**REGULAR MEETING OF THE
CITY OF CONCORD
DESIGN REVIEW BOARD**

- 1. [Chalomar Crossings Subdivision](#) (PL150027 – DR) – Study Session for Rezoning from RS-7 to RL, Major Subdivision tentative map to create 20 lots, Planned Development Use Permit, Design Review, and a Tree Removal Permit on a 2.48-acre site located at 988 Oak Grove Road. The General Plan designation is Low Density Residential; Zoning classification is RS-7 (Single-Family Residential 7,000 square foot minimum lot size); APN 129-210-015. **Project Planner: Joan Ryan @ (925) 671-3370****
- 2. [Kamyshin Minor Hillside Development](#) (PL15005 – HM, DR) – Study Session for a 2,750 square foot single-family residence on a 0.42-acre site located at 3687 Treat Boulevard. The General Plan designation is Rural Residential; Zoning classification is RS-15 (Single-Family Residential 15,000 square foot minimum lot size); APN 130-230-044. **Project Planner: Joan Ryan @ (925) 671-3370****

MEMORANDUM

SUBJECT: Site Design Review of Circulation and Orientation for Chalomar Crossings
Study Session – Request for Feedback

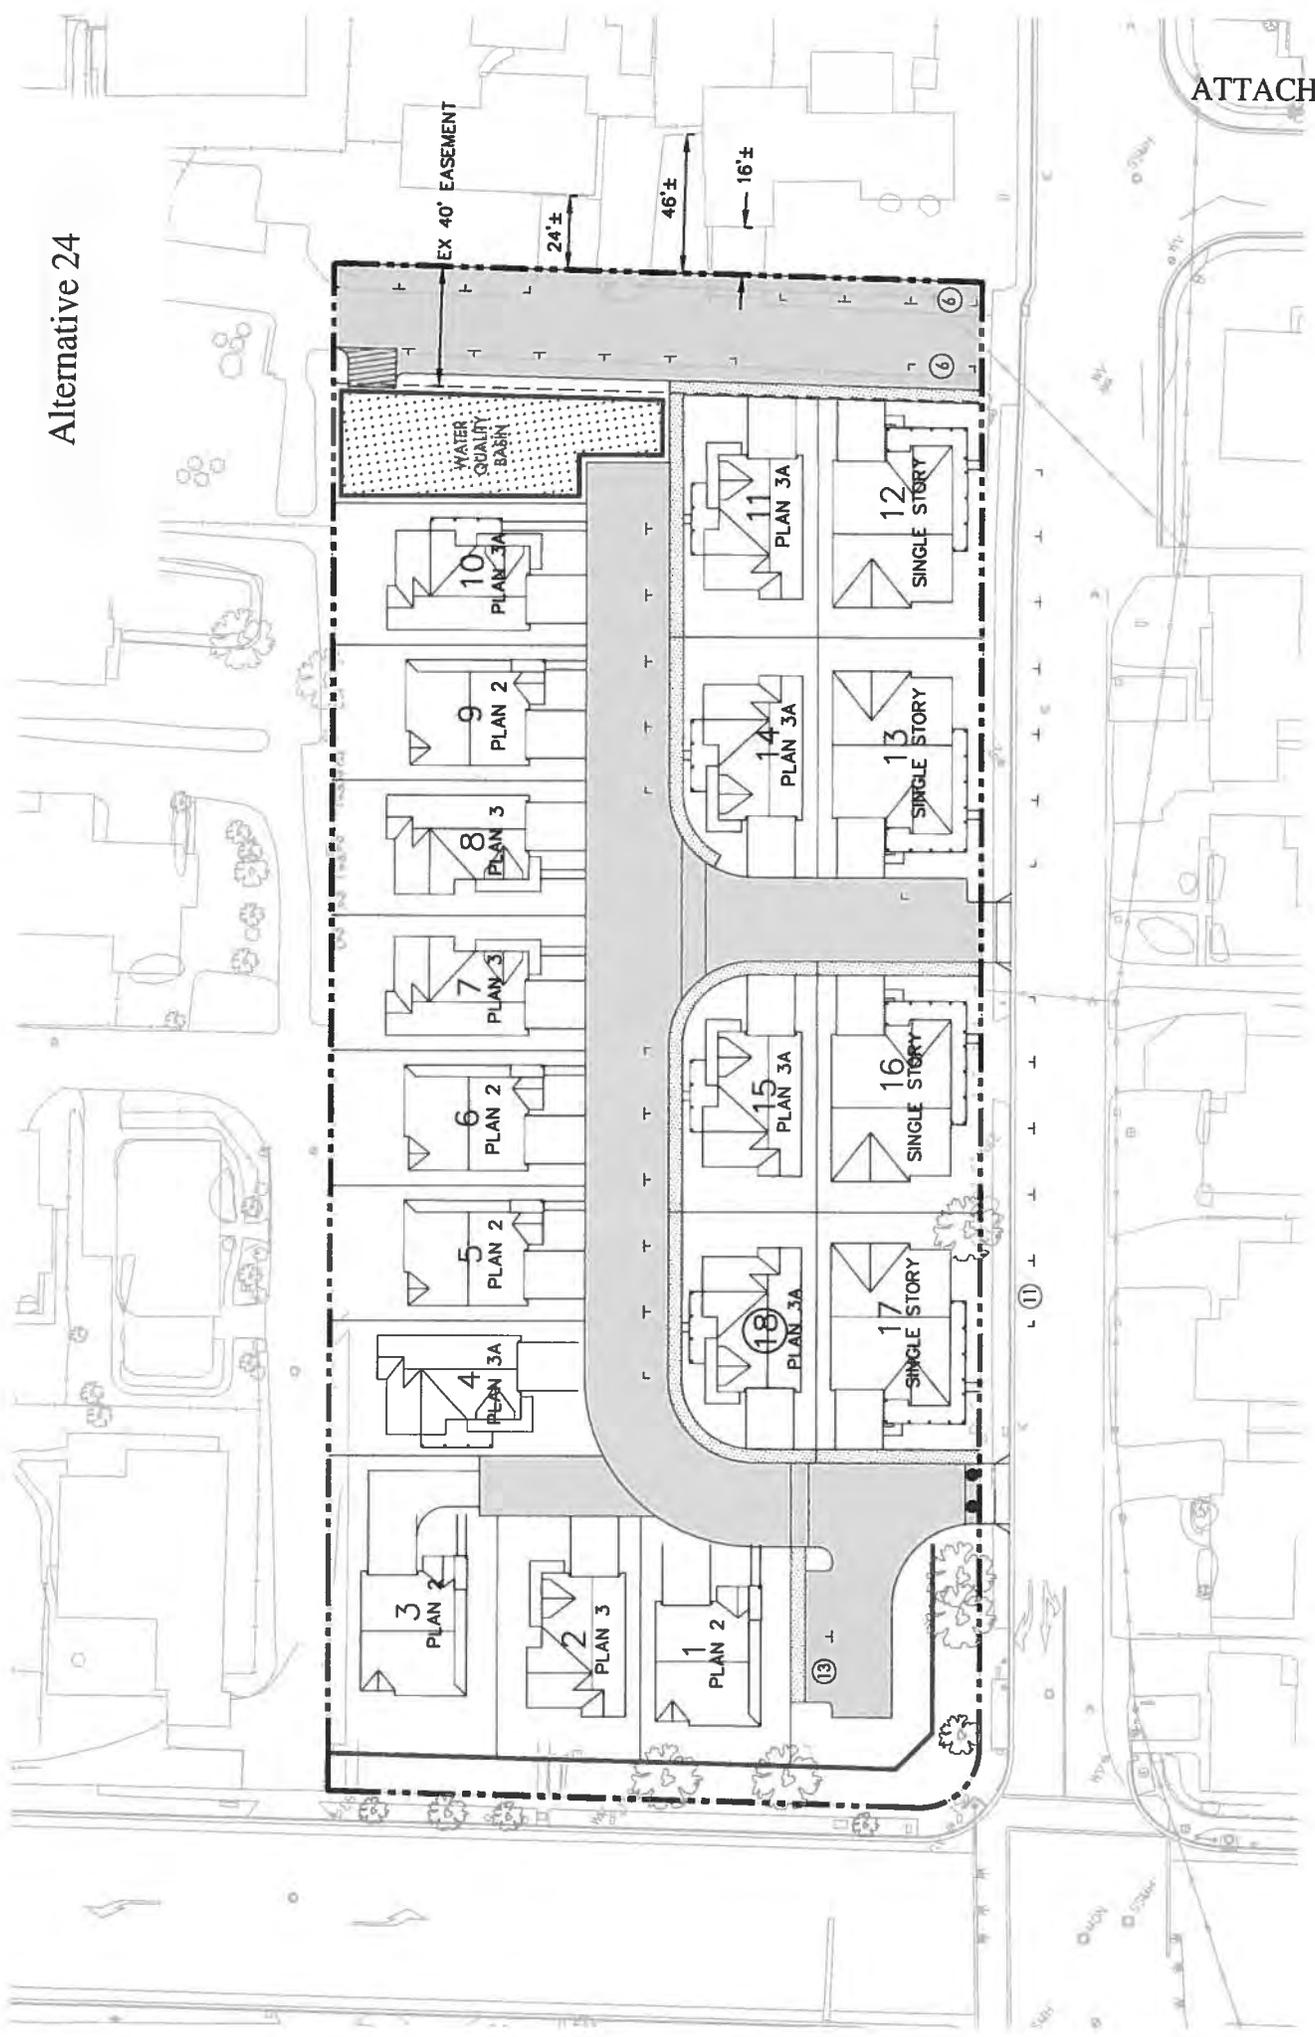
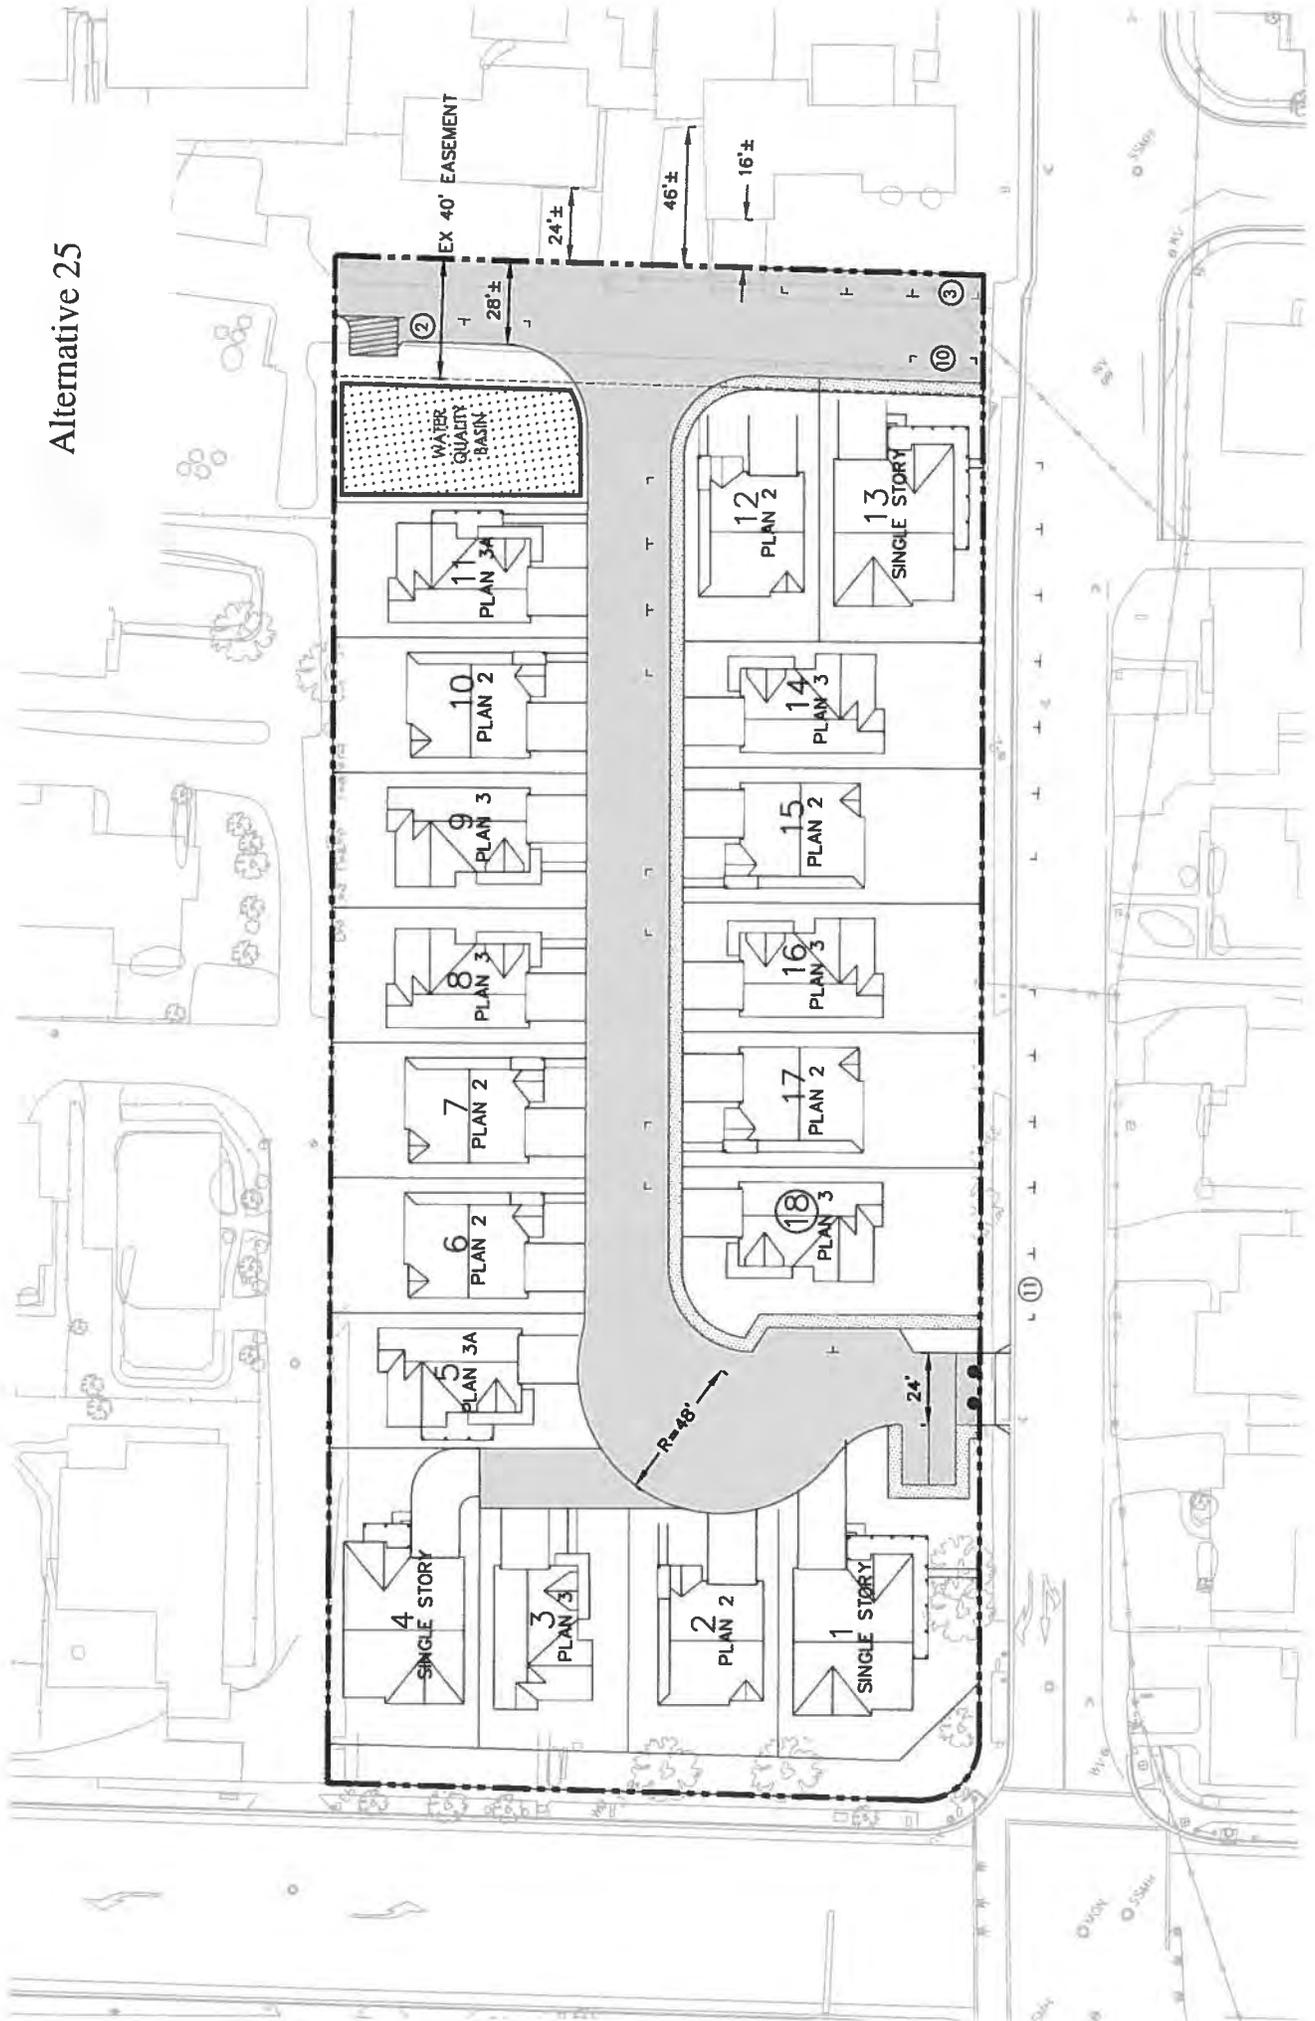
Staff recommendation: *Alternative 24 is preferred over Alternative 25 based on the amount of additional parking provided, the lesser vehicular impact on the neighbors to the east, and the reduced number of homes along Oak Grove Road. Staff also prefers the side orientation of homes to Chalomar as opposed to backing the units. However, the homes along the northern boundary are still very tight and all 2-story. Staff recommends the inclusion of 1-2 one-story units along this edge to break up the appearance of a wall of homes along that edge, and exploration of a foot path to the north, if feasible.*

FARMHOUSE FRONT ELEVATION

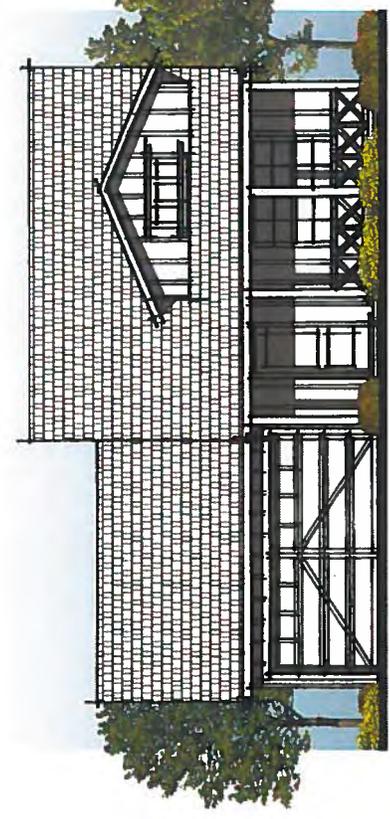
Staff comment: *On Farmhouse side elevation, consider board and batt siding with another material, to break up and reduce verticality.*

PLAN 2 FRONT ELEVATIONS

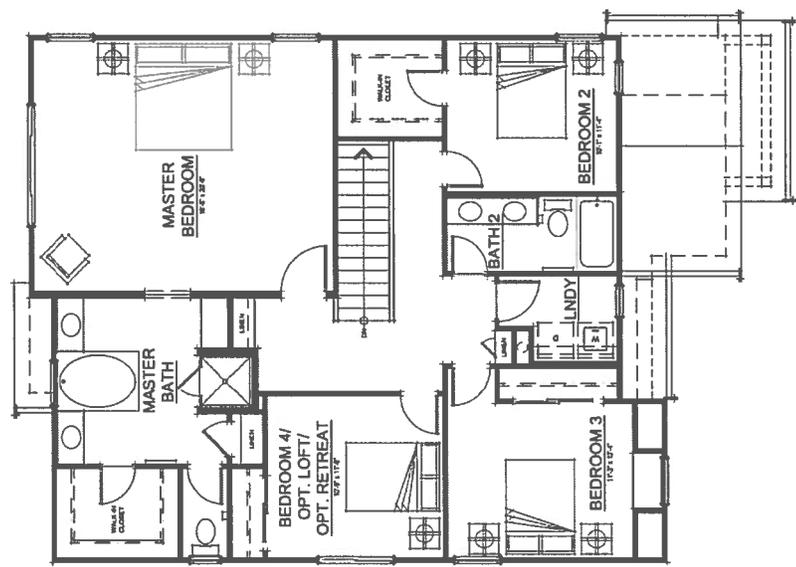
Staff comment: *Farmhouse porch should be carried across gable. Decorative windows on all should be standard not optional.*

PLAN 3 FARMHOUSE ELEVATIONS AND ROOF PLAN

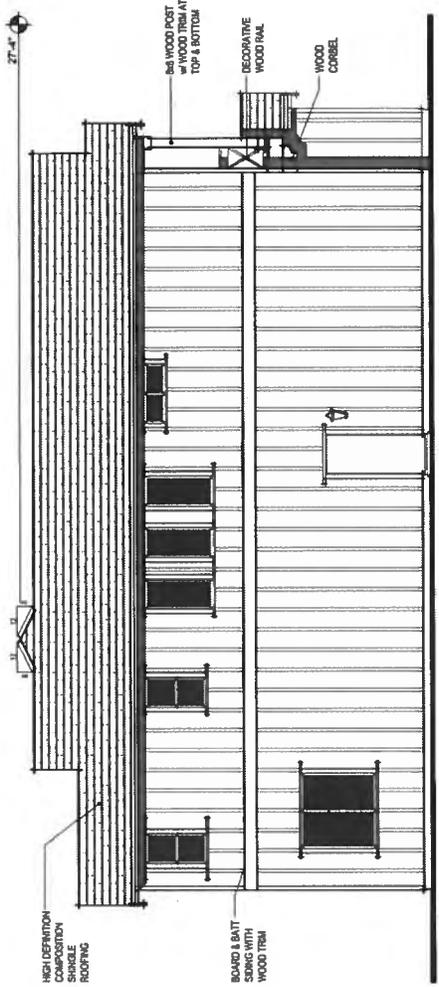
Staff comment: *Add belly band to front elevation to break up verticality and lower wood accents under top gable*

TRADITIONAL REAR ELEVATION

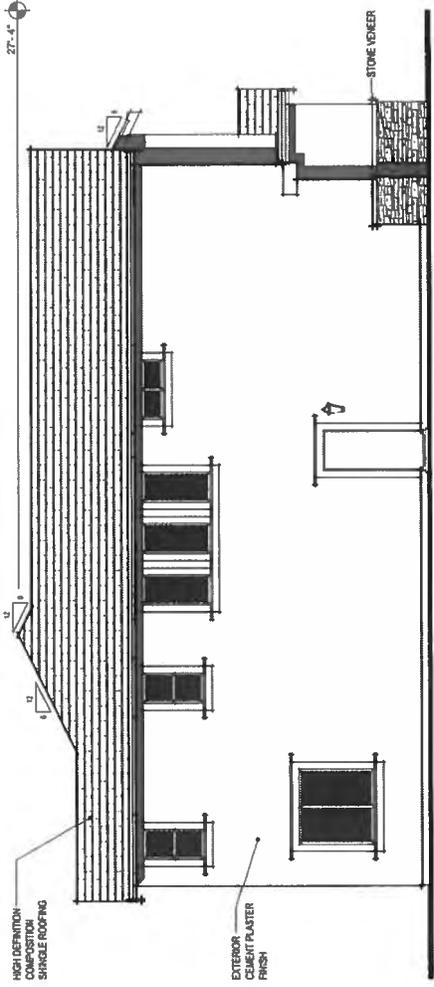
Staff comment: *Add Stone on rear elevation-should be noted to return to fence line.*
